Addendum	01
Date:	July 28 th , 2026
Project:	KGCC – Clubhouse 2026-01
Address:	777 Clonsilla Av. Peterborough, On

1 INTENT

4. ARCHITECTURAL DRAWINGS

PROJECT	KAWARTHA GOLF AND COUNTRY CLUB HOUSE 777 Clonsilla Avenue Peterborough, Ontario
TITLE	TEMPORARY POWER SERVICE
FILE No.	586
DWG. No.	E1T

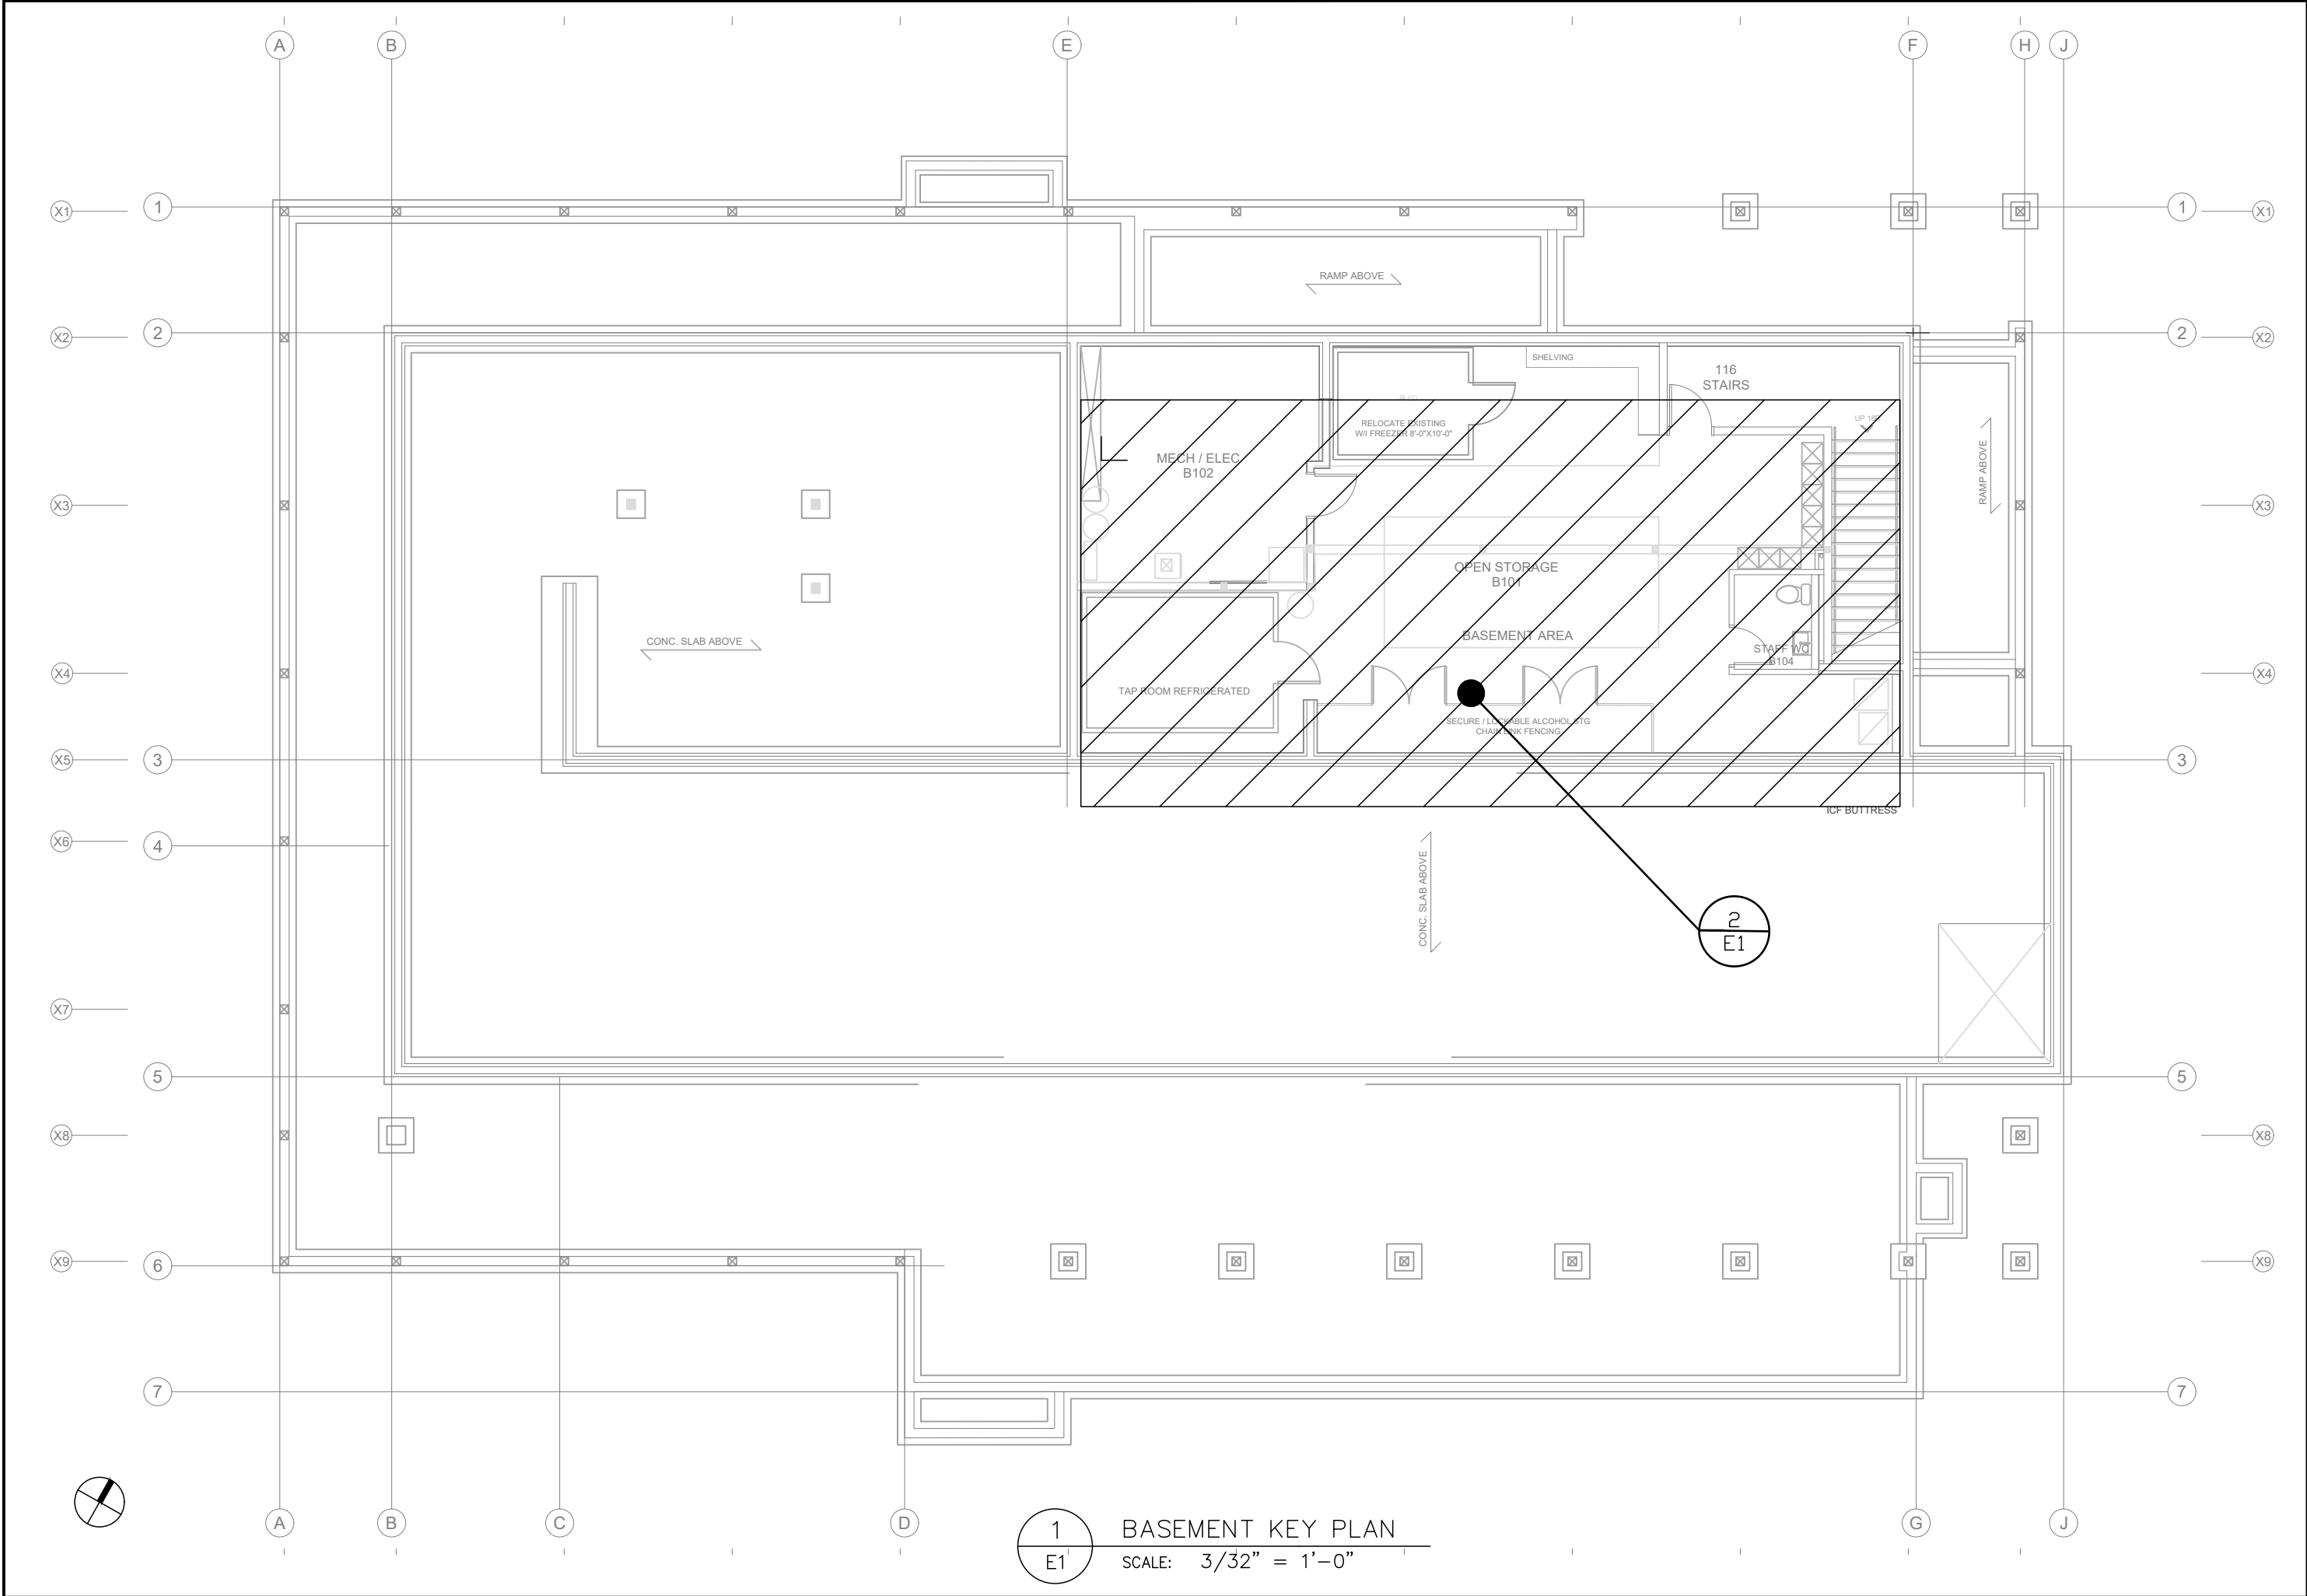
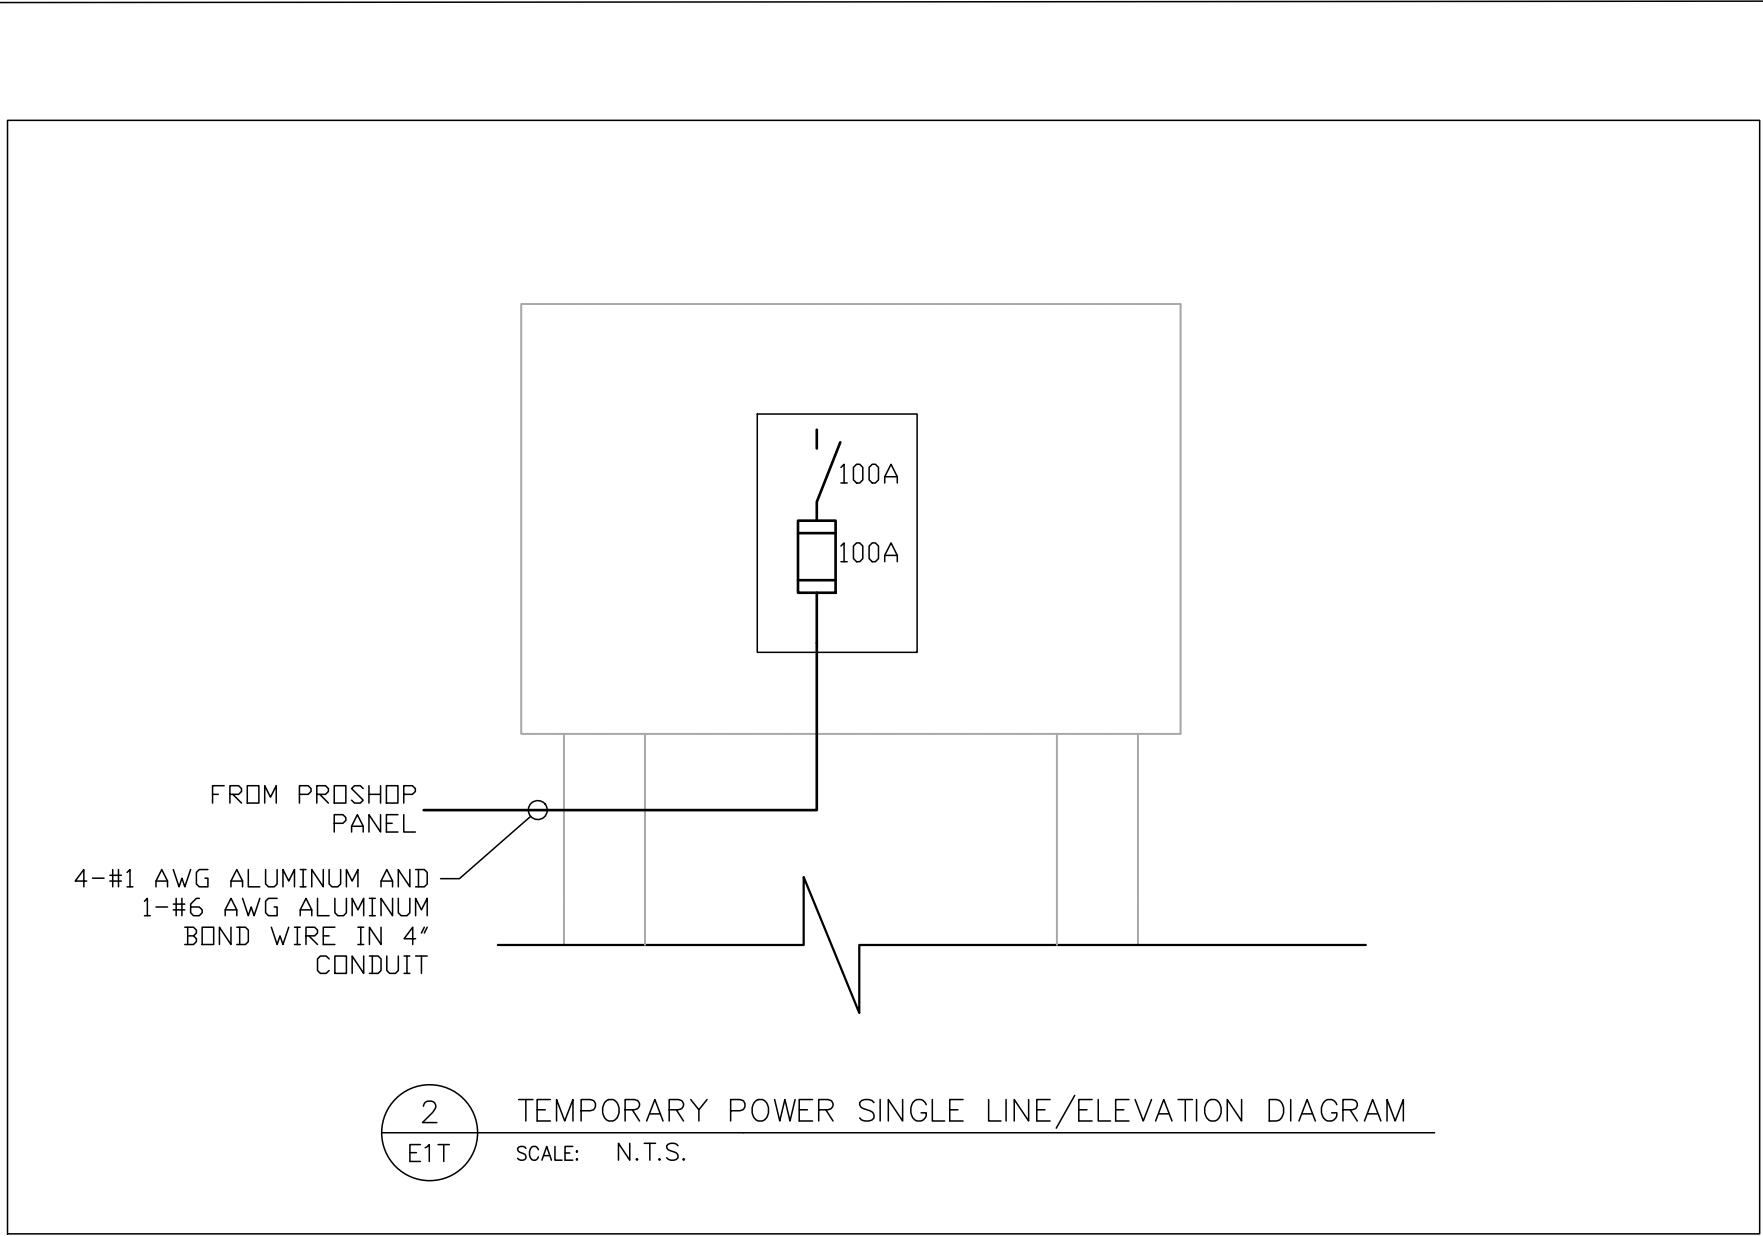
7.1.1 ADD Temporary power drawings to contract: E1T.
